MFN 06-274

Subject: Response to RAI Letter Number 20 Related to ESBWR Design Certification Application – Seismic Design – RAI Numbers 3.7-16, 3.7-24, 3.7-27, 3.7-30, 3.7-32, 3.7-33, 3.7-35, 3.7-37, 3.7-38, 3.7-39, 3.7-50, 3.7-54 and 3.7-57

**Response to NRC RAI Letter No. 20 Related to ESBWR Design
Certification Application**

Shimizu Engineering Report																	
Project	General Electric Company ESBWR Project		Shimizu Document No.	SER-ESB-033													
Title	Parametric Evaluation of Effects on SSI Response		Rev.	0													
			Issued Date	8/14/06													
			Revised Date														
<p>NOTE:</p> <p>This document provides additional SSI analyses performed and results obtained for the Reactor/Fuel Building Complex (RBFB) the Control Building (CB) to address the following issues identified in RAIs.</p>

Figure 7.2-11 Floor Response Spectra - RSW Top Y

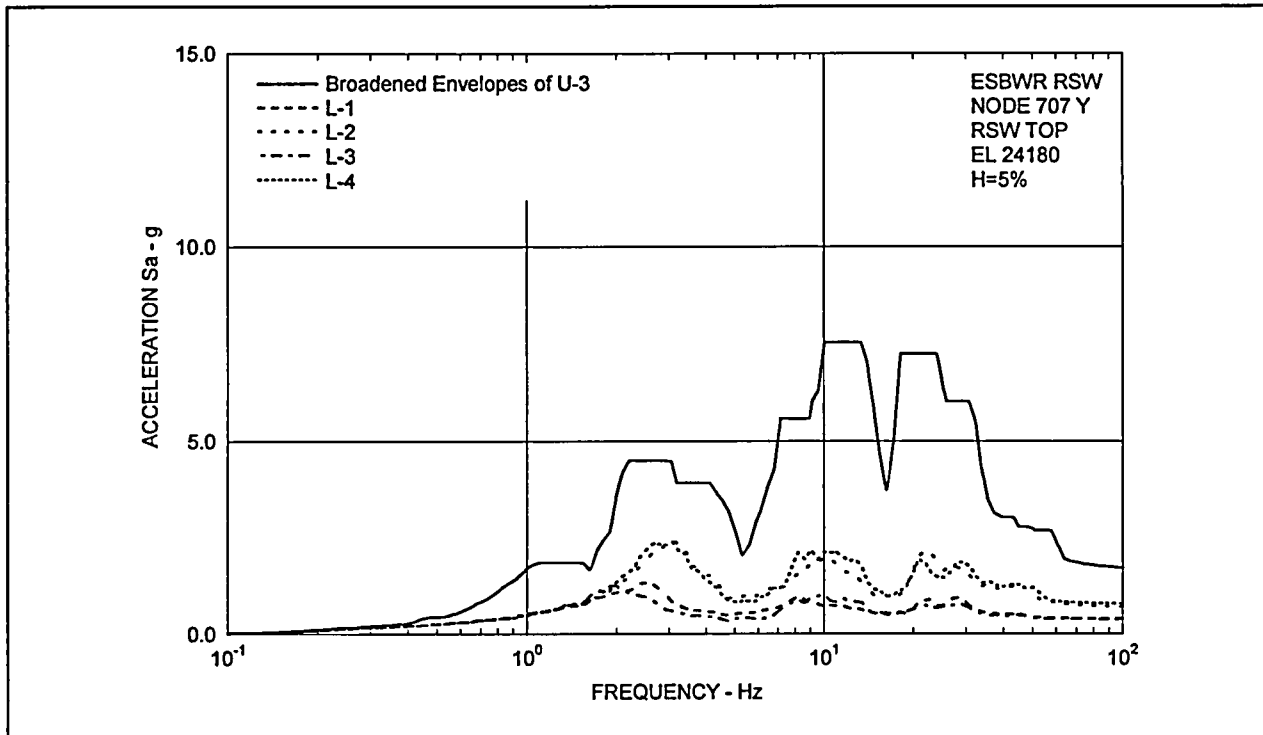
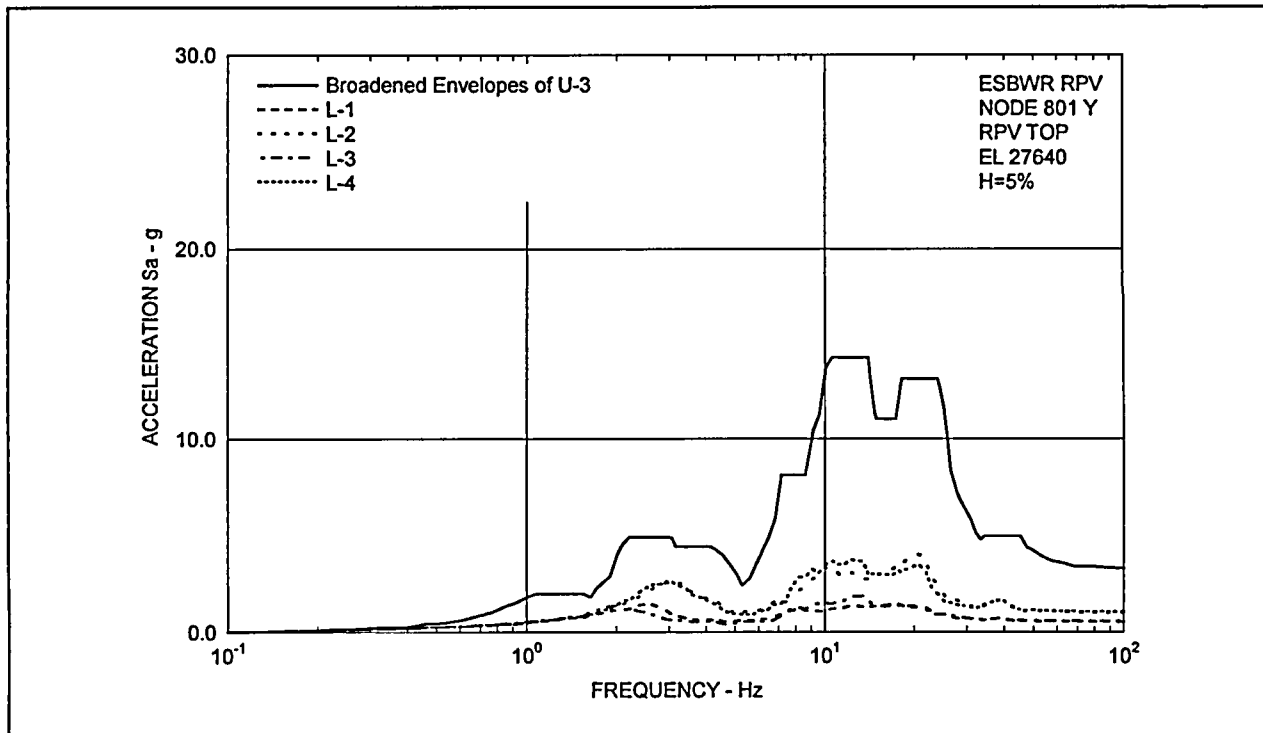
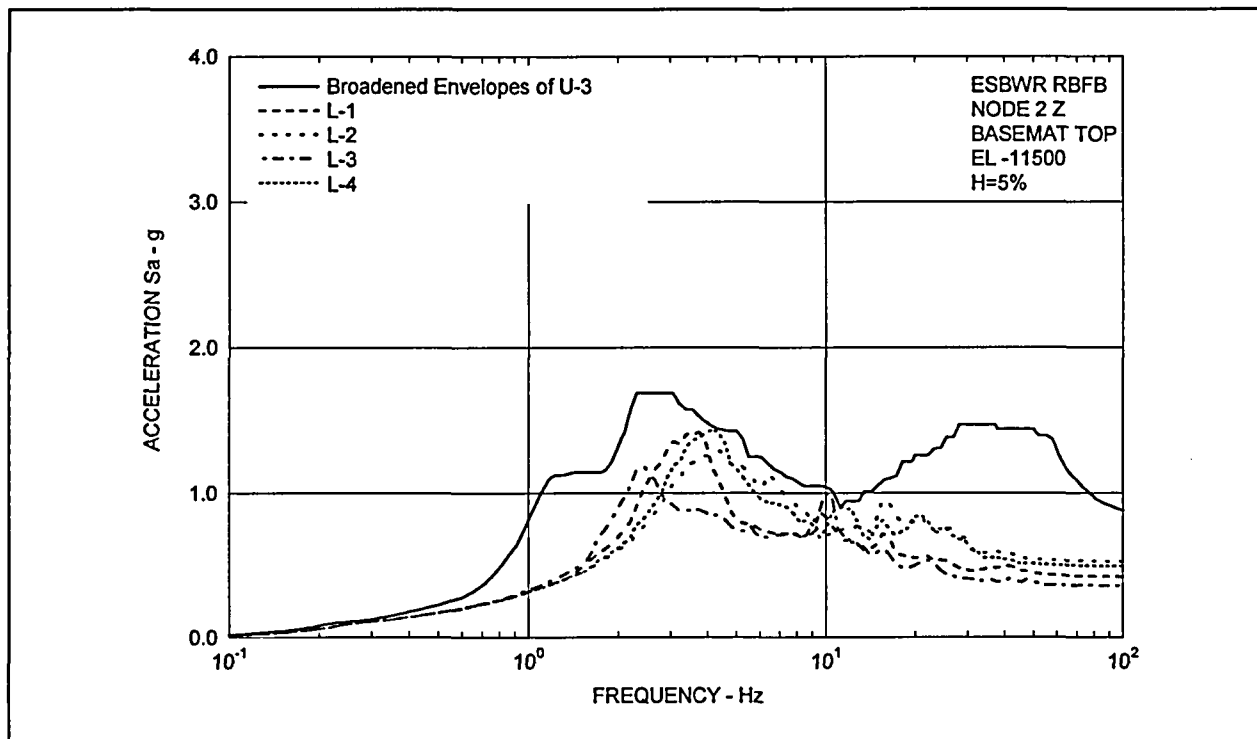
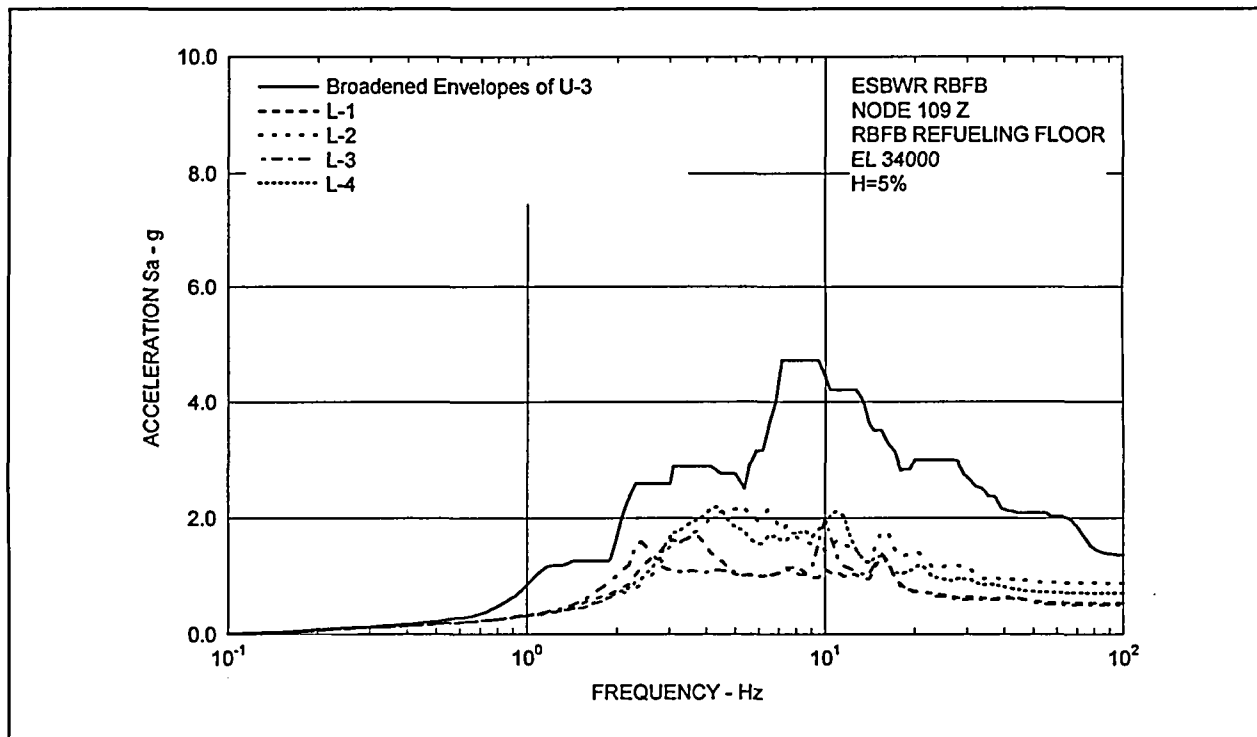
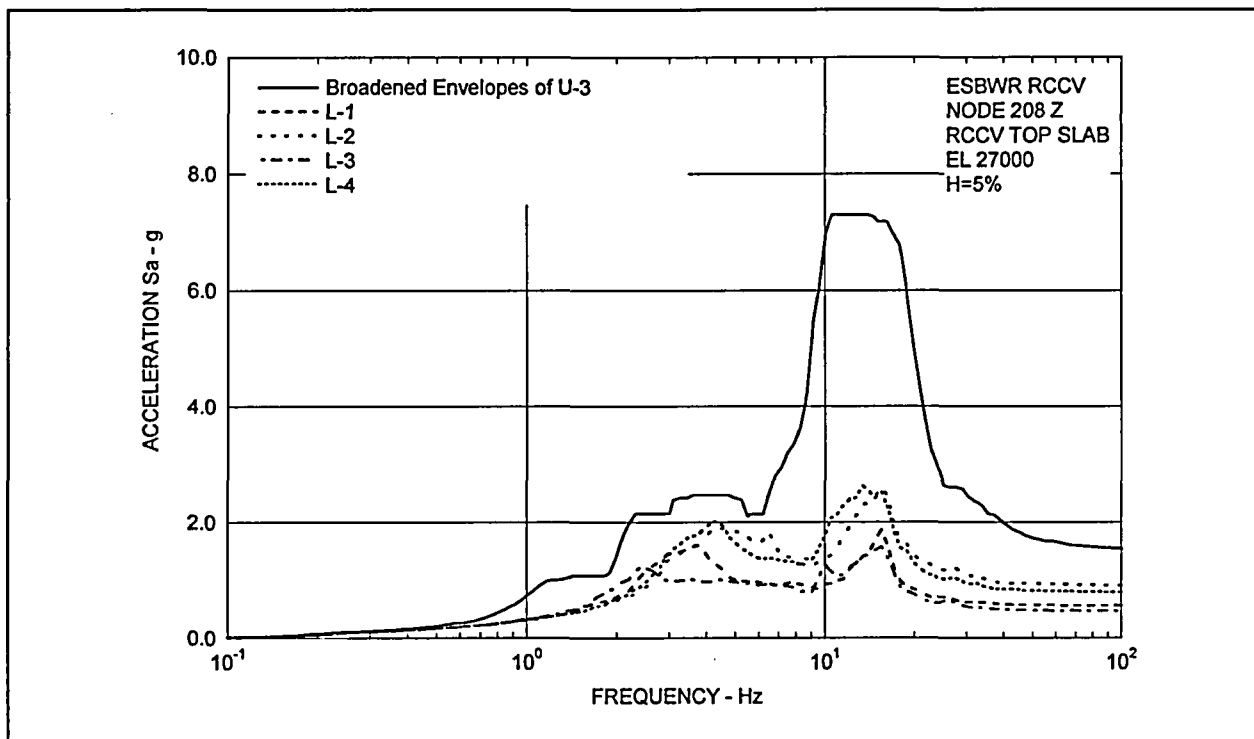
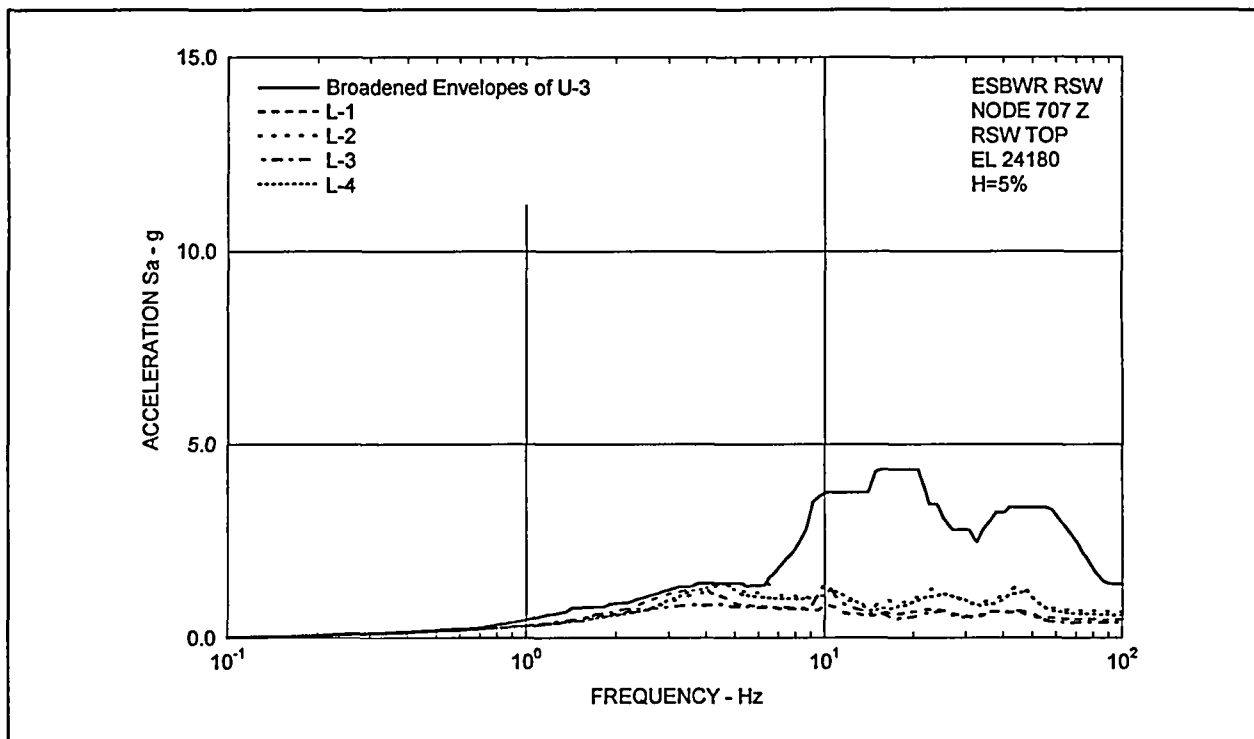
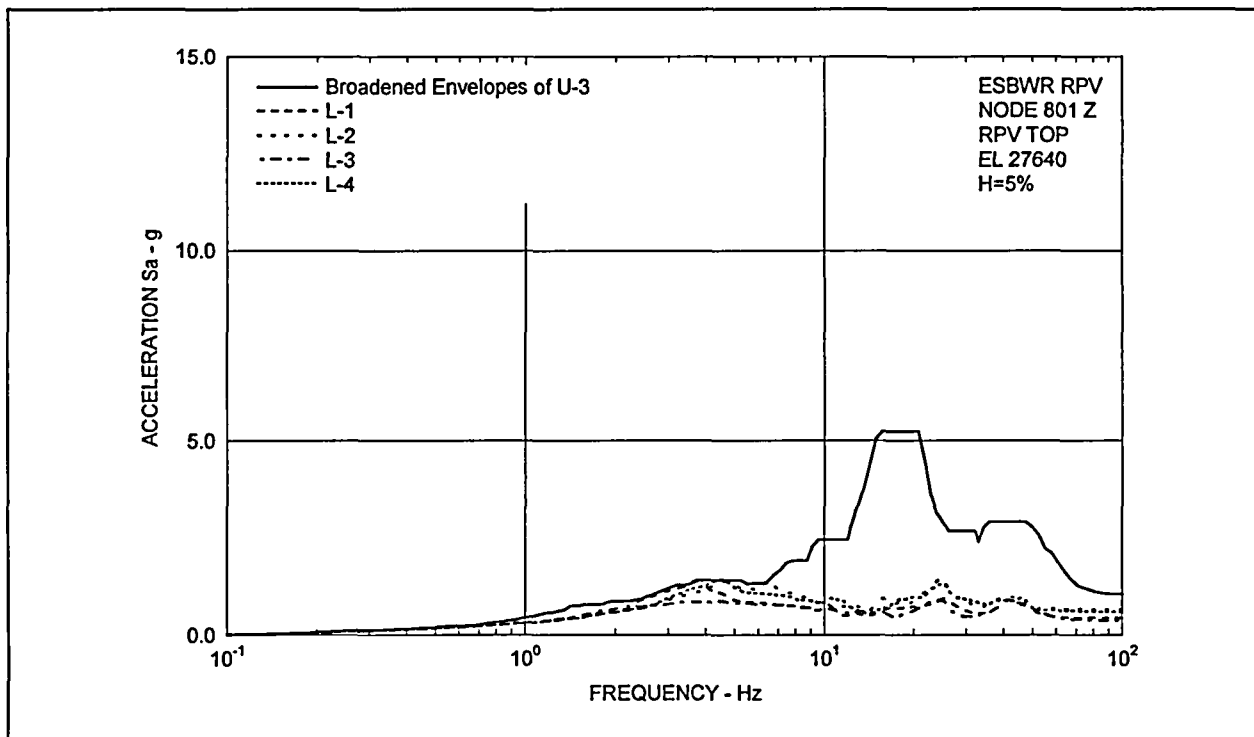
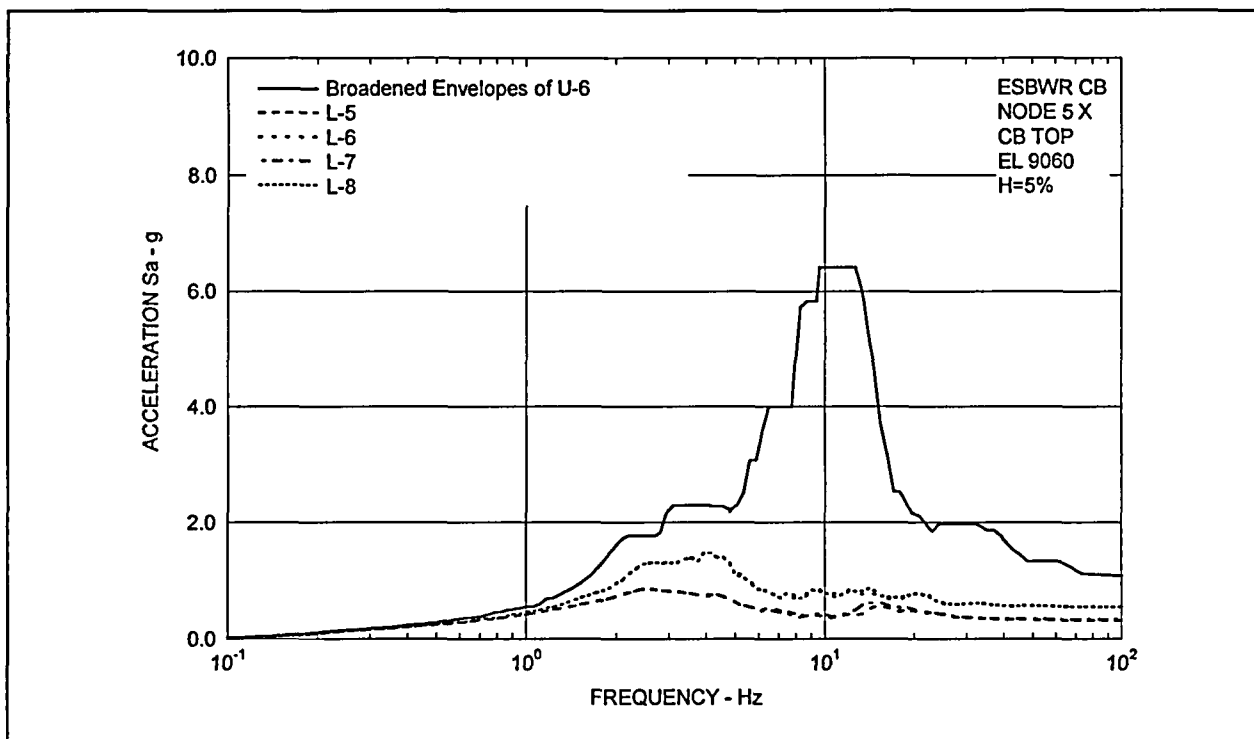
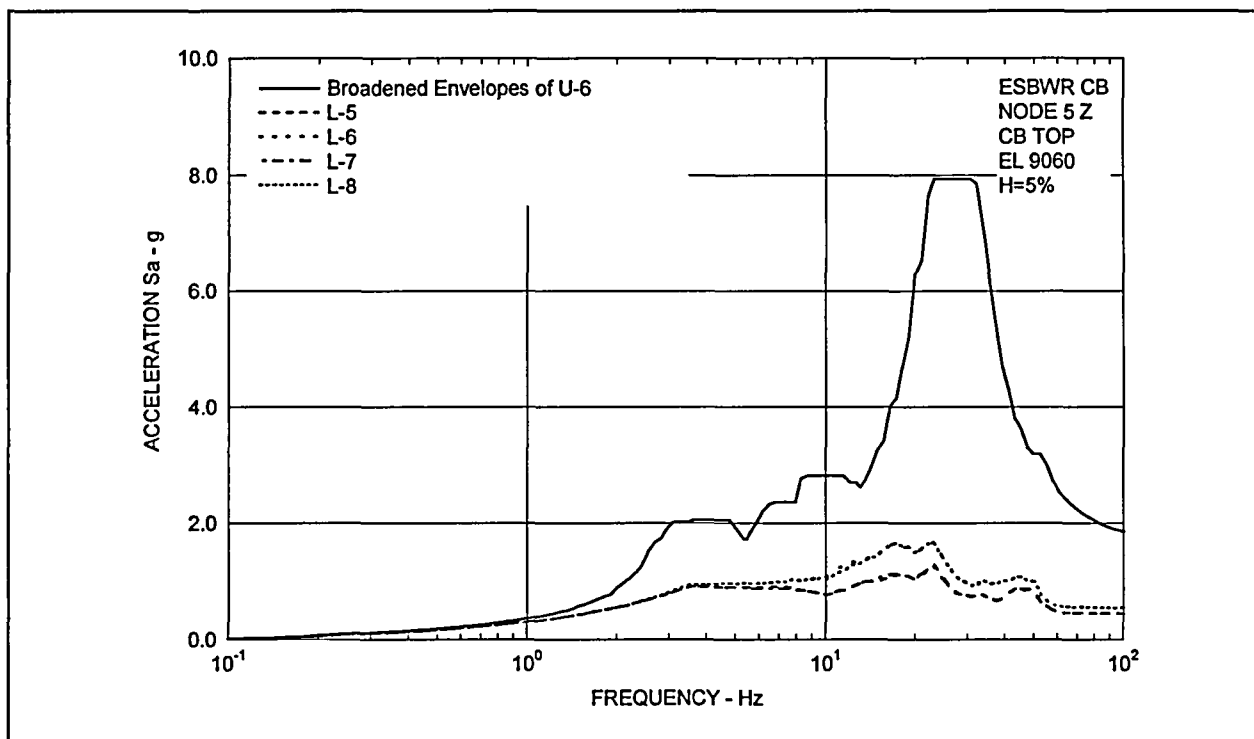
The last part of the second paragraph on page 3A-4 of DCD Section 3A.3.1 states that three subsurface conditions (soft, medium, rock and hard rock sites) are considered to be uniform half-space, as provided in Table 3A.3-1 for SSI analyses. According to the staff's review experience, there are a number of sites composed of layered materials that should be considered for siting of nuclear plants. Such sites may have significant variation of shear wave velocity with depth, leading to potentially significant impedance mismatches between layers. Such profiles can have effective impedance functions that are significantly different from those associated with a uniform half-space. (See for example, "Handbook of Impedance Functions" by Sieffert and Cevaer). These sites are typically characterized by impedance functions that are highly frequency-dependent, particularly those associated with radiation damping. The approach of using a frequency-independent assumption for both stiffness and damping in SSI may lead to significantly different computed responses. The behavior (or response) of a massive structure (such as RB/FB or CB) may be significantly influenced by these variations due to site conditions. For the design of a standard plant such as ESBWR, the DCD should address the limitations on site layering that will be required, to ensure the applicability of the ESBWR design, which is based on the assumption of uniformity. The staff requests the applicant to include this information in the DCD, and also identify it as a COL interface item.

Comparisons of floor response spectra (FRS) (5% damping) at selected RBFB locations are shown in Figures 7.2-1 through 7.2-18. Similarly, FRS (5% damping) at selected CB locations are compared in Figures 7.2-19 through 7.2-21.

It is found from the results that the responses for the layered site cases are bounded by the broadened envelope responses of uniform site cases in the whole frequency range.

As stated in Section 7.1, the existing DCD design load will be updated to incorporate the responses due to the single envelope input motion at the uniform sites. The revised DCD design load has no impact from the response results for the layered sites.
